PRODUCT CHANGE NOTIFICATION

#PCN-DC-KLKJ-15

Business Unit	Product Line Code	Type of Change	Action	Date of issue
DC	AAB	Mechanical	Notify Distributors and Field	7/30/2015

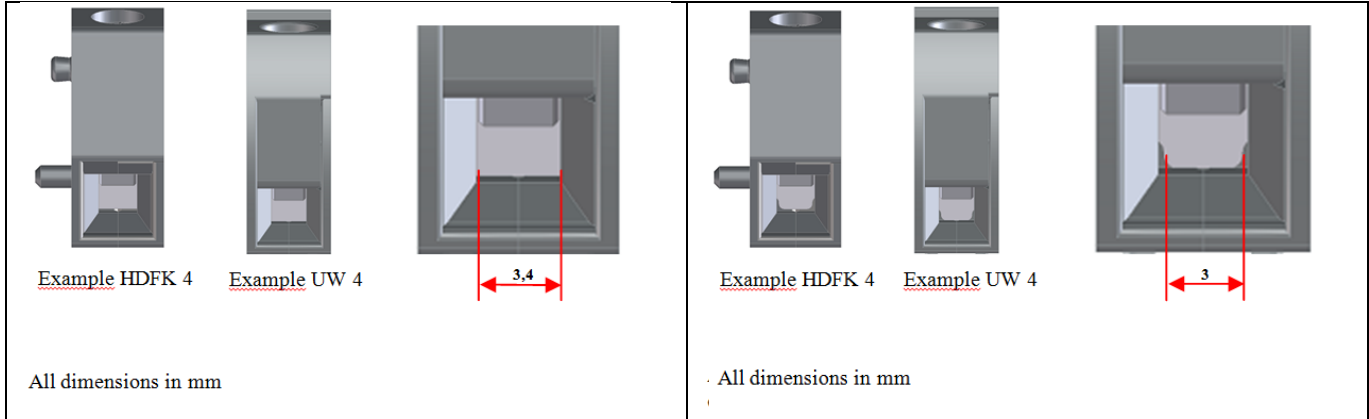
Upon tooling investigation it was found that we could minimize cost increases on this product line by utilizes a metal clamping sleeve used on our rail mounted terminal blocks. Because of this change there is a slight narrowing of the change at the bottom of the wire entry. See images below.

This change does not affect the wire gauge or any other technical data.
